Washington PSR

**Re: New Information regarding Seismic Hazards at the WPPSS-2/Columbia
Generating Station nuclear power plant**

EARTHQUAKE RISK FACTORS AT THE COLUMBIA GENERATING STATION (formerly known as WPPSS WNP-2)

Evaluation of Energy Northwest Response (letter dated 17 September 2010) to Nuclear Regulatory Commission Request 3a (letter dated 13 July 2010) for Additional Information on Seismic Hazards for the Review of the Columbia Generating Station License Renewal Application

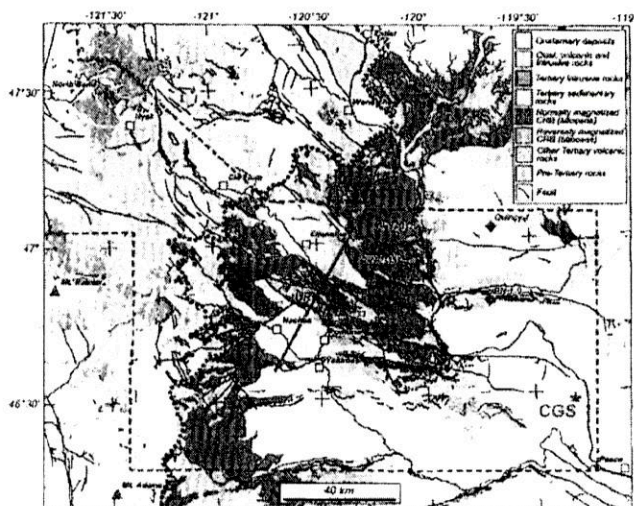
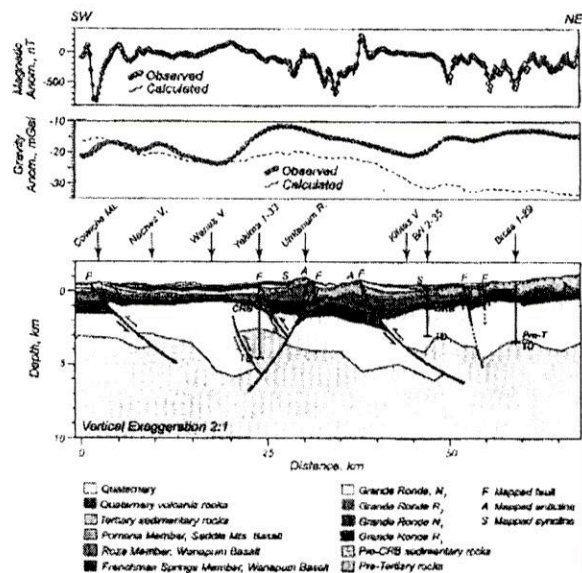
Mapping and analysis of geologic structures (faults and folds) was conducted and their potential to generate earthquakes was also assessed. Based on the state of geologic knowledge at that time, it was determined that no **capable faults**¹ existed within a 5 mile radius of the Columbia Generating Station (WPPSS, 1981) and "... *surface faulting is not a factor in the design of the plant.*" (WPPSS, 1981, p 2.5-143). Their seismic risk assessment also included a panel of experts who evaluated all known geologic structures (faults) that might potentially generate earthquakes which could impact the Columbia Generating Station. Based on their review, six Yakima Fold and Thrust Belt geologic structures were identified as potential seismic (earthquake) sources (WPPSS, 1981). These six Yakima Fold and Thrust Belt structures were (highlighted in brown on Figure 1) :

- Additional Yakima Fold and Thrust Belt structures were identified that could potentially generate earthquakes that could pose a risk to the Hanford Site and the Columbia Generating Station facilities (USDOE, 1988; Geomatrix, 1990, 1996). These additional "faults" included (highlighted in purple and red on Figure 1):

By 2009 additional data from deep hydrocarbon exploratory wells and geophysical surveys provided compelling evidence that the major faults along the Yakima folds were “coupled” (Reidel and Tolan, 2009; Blakely et al., 2009; Tolan et al., 2009). Figure 1 presents a U.S. Geological Survey developed crustal model cross-section across the Umtanum Ridge structure depicting the “coupled” nature of the major faults.

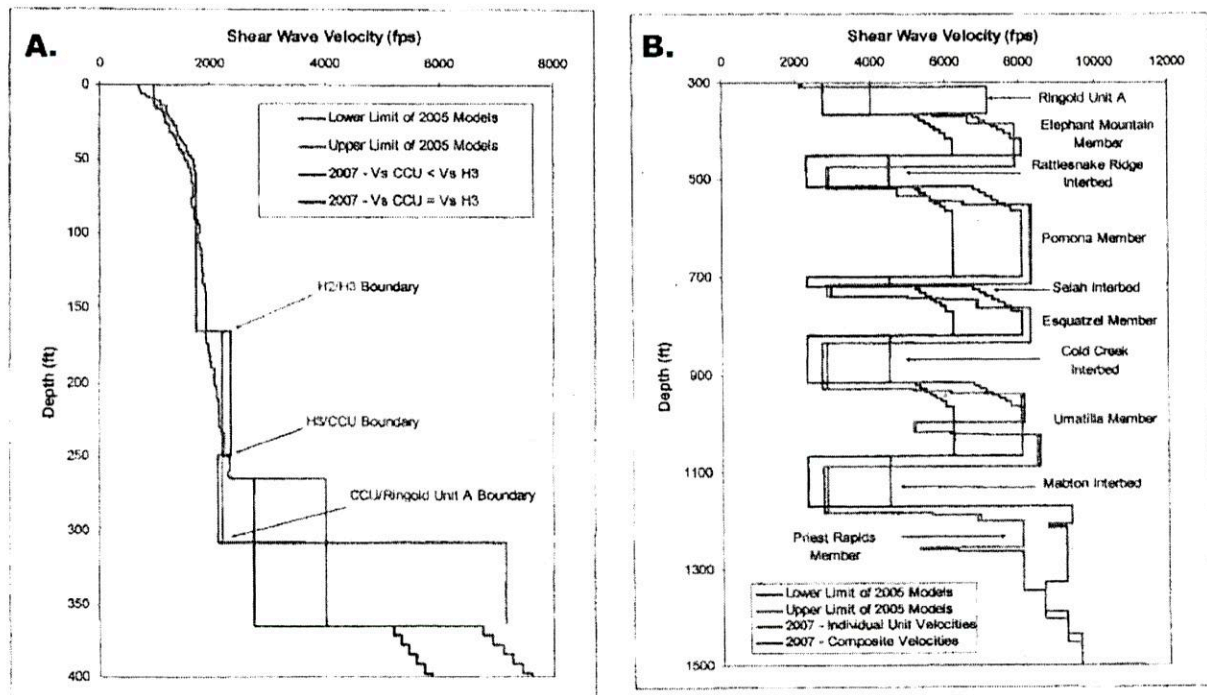
Figure 3 presents shear wave velocity profiles for the sedimentary units and Columbia River basalt/Ellensburg Formation interbeds beneath the Waste Treatment Plant site (Youngs, 2007). Note that measured shear wave velocities in the non-indurated Hanford Formation are much lower than that for the indurated Ringold Formation which in turn appears to be more akin to the Columbia River basalt flows (Figure 3B). Note the significant difference in the vertical shear wave velocity profiles (through the Hanford and Ringold Formations) at the CGS site (Figure 4) in comparison to that for the Waste Treatment Plant site (Figure 3).

Energy Northwest’s response (p. 40-41) cited the revised Waste Treatment Plant site ground motion models based on the vertical shear wave profiles (Figure 3; Rohay and Reidel,

Figure 4. Vertical shear wave velocity profile beneath the Columbia Generating Station (WNP-2 on left-hand graph). Reproduced from Geomatrix (1996, Appendix A, Figure A-2, p. A-18).

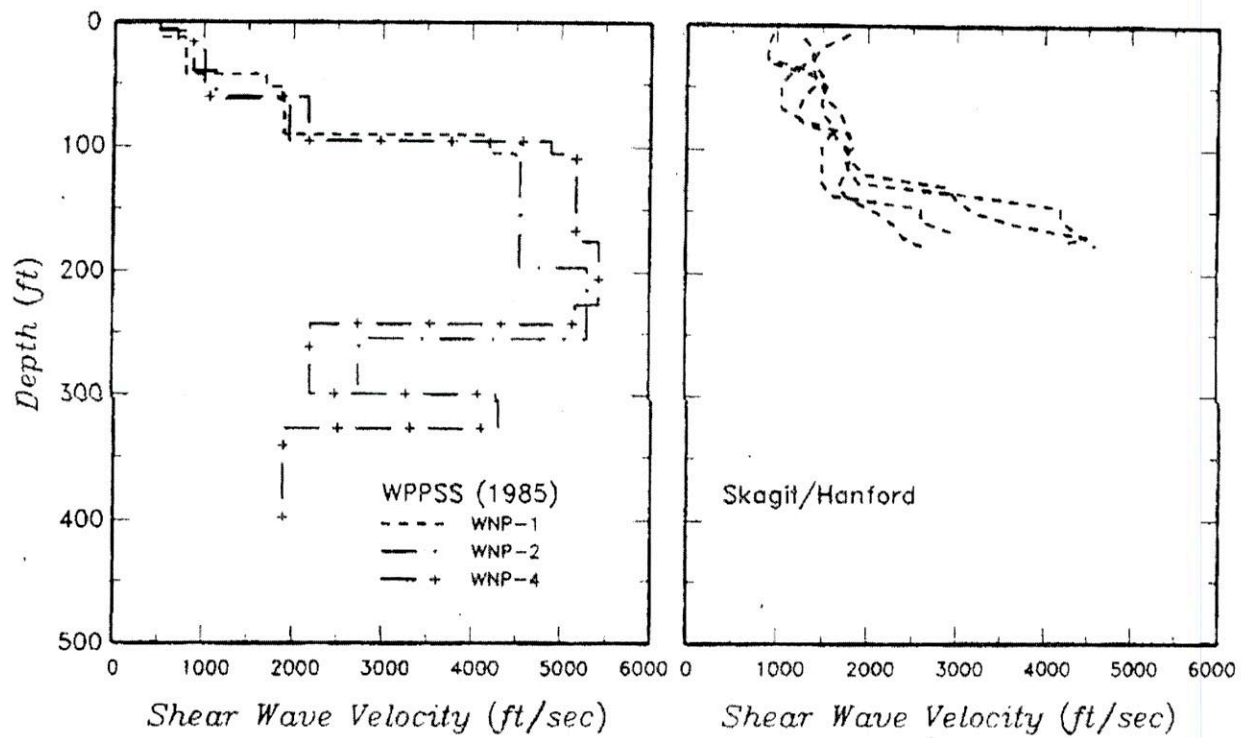
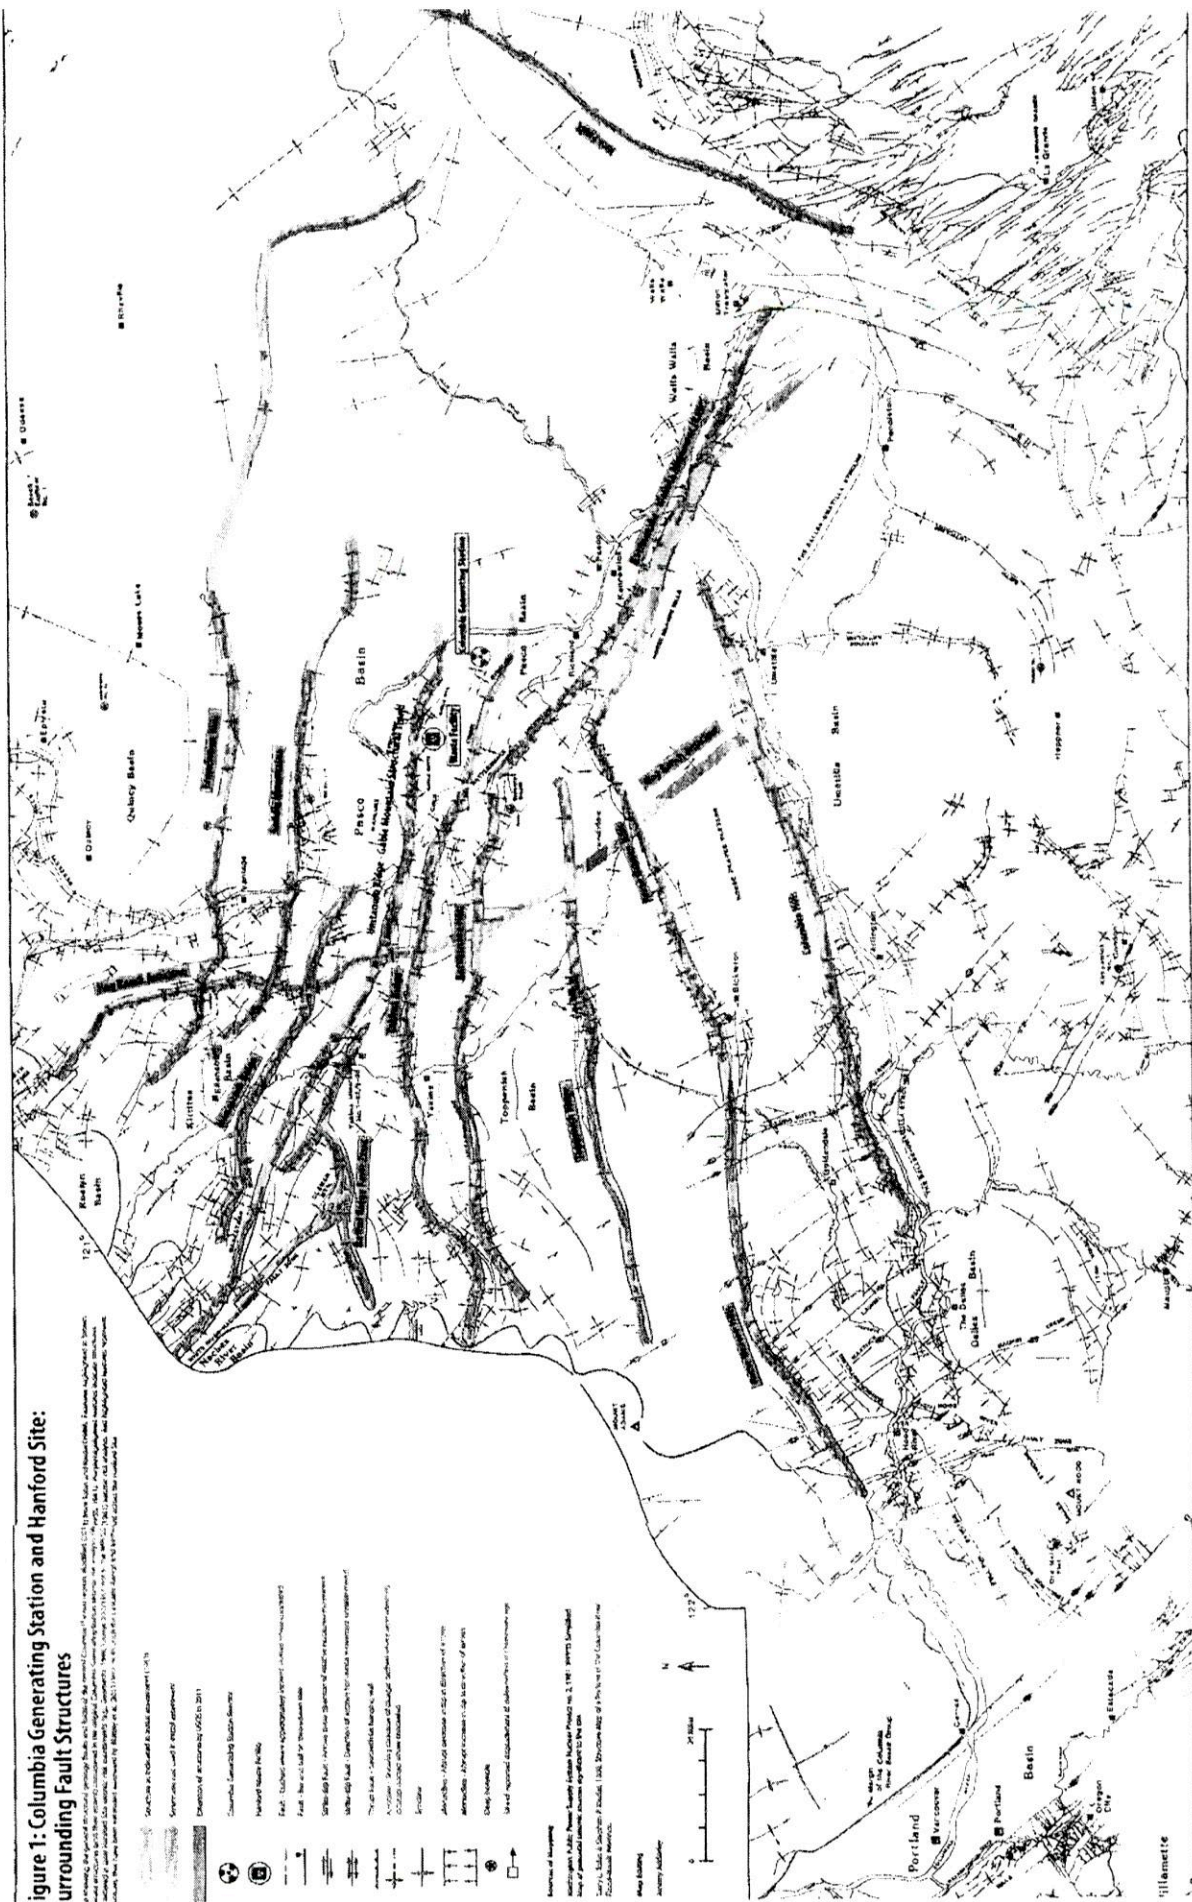
2007; Youngs, 2007) as being similar to ground motion results obtained from the seismic hazards model used by CGS (Geomatrix, 1996). As noted by WPPSS (1981), Geomatrix (1996), Rohay and Reidel (2005), and Youngs (2007), site-specific models for seismic ground motion need to be developed and used. For the CGS site this would require Energy Northwest to integrate the Waste Treatment Plant shear wave velocity data for the Columbia River basalt/Ellensburg Formation interbeds (Figure 3B) with the Ringold Formation shear wave velocity profile (Figure 4). This re-assessment has not been done for the CGS site.
